Request	-	Special Use Permit for Day Care Center
Location	-	1119 W Bancroft Street
Applicant	-	Danielle Yowpp 1930 Freeman Street Toledo, OH 43606
Owner	-	William J Kubacki, Reverend Monsignor, Trustee Et Al. 1119 W Bancroft Street Toledo, OH 43604
Engineer	-	John A. Weithman, P.E. P.O. Box 189 Genoa. OH 43430
Site Description		
Zoning	-	CR & RD6 / Regional Commercial & Duplex Residential – 6,000 SF
Area Frontage	-	 ±1.977 Acres (86,118 SF) ±210' along W Bancroft Street ±275' along Forest Avenue ±400.5' along Horace Street ±285' along N Detroit Avenue
Existing Use Proposed Use	-	Parish campus with added Day Care Center
Area Description		
North South East West	- - -	Retail, restaurants, gas station / CR & CR-SO Single-family homes, duplexes / RD6 Retail, restaurants, elementary school / CR & RD6 Single-family homes, duplexes, manufacturing / IL

The staff recommends that the Toledo City Plan Commission recommend approval of SUP-9001-23, a Special Use Permit for a Day Care Center at 1119 W Bancroft Street to the Toledo City Council, for the following two (2) reasons:

SPECIAL USE PERMIT TOLEDO CITY PLAN COMMISSION REF: SUP-9001-23 DATE: March 14, 2024 TIME: 2:00 P.M.

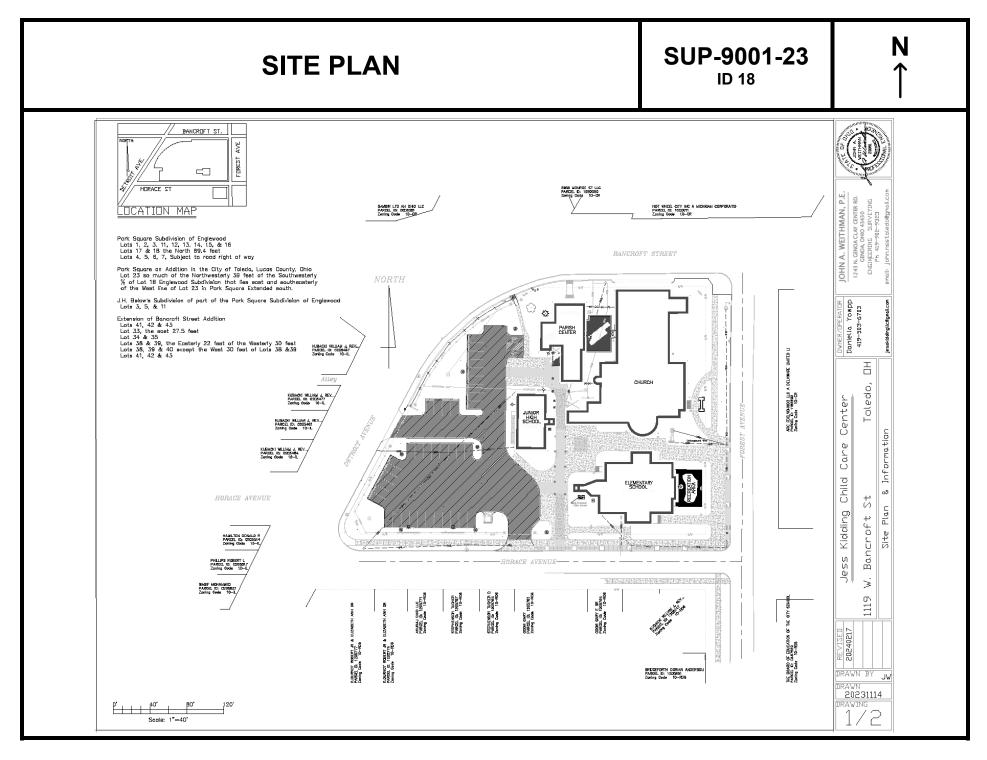
- 18. Per TMC§1104.0703(E) a Day Care Center is required to provide 60 square feet of useable outdoor space for each person in their care using the outdoor space at any one time. The site plan depicts a fenced outdoor area that is approximately 600 square feet in area that is enclosed by a 42 inch high galvanized chain link fence around the north, south and east perimeter. An existing building wall will act as the west boundary. A five foot wide gate is proposed on the north side of the outdoor area with a six foot wide concrete walk from the fence to an existing sidewalk. Acceptable as depicted.

- 21. Per the Off-Street Parking Schedule in TMC§1107.0304 a day care center is required to provide 1 bicycle space for every 10 parking spaces; or per TMC§1107.0901(B) a minimum of two bicycle parking slots shall be provided when the provision for bicycle parking slots is required. The site plan depicts two bicycle racks. Acceptable as depicted.

- 23. Four copies of a revised site, fencing and landscaping plan (separate from building & site plans) shall be submitted to the Plan Director for review and approval. Such plan shall include:

- a. Per TMC§1104.0703(E) a Type B landscape buffer is required around the outdoor space in accordance with TMC§1108.0203(F). This section requires a landscape

buffer of 10 feet in width with three canopy trees and 11 shrubs to be installed for the proposed 70 foot outdoor area perimeter. The site plan depicts a 42 inch high galvanized chain link fence with a 10 foot wide landscape buffer on the east and a 15 foot wide buffer on the north and south containing 15 shrubs and two trees. Four existing trees are also located within the buffer area. Acceptable as depicted.

- b. The location of the proposed outdoor area is currently heavily shaded by the four existing trees. The two proposed trees shall be installed to the south of the outdoor area, in the grass area between the internal site sidewalk and the street sidewalk, or elsewhere on the site as approved by the Plan Director.
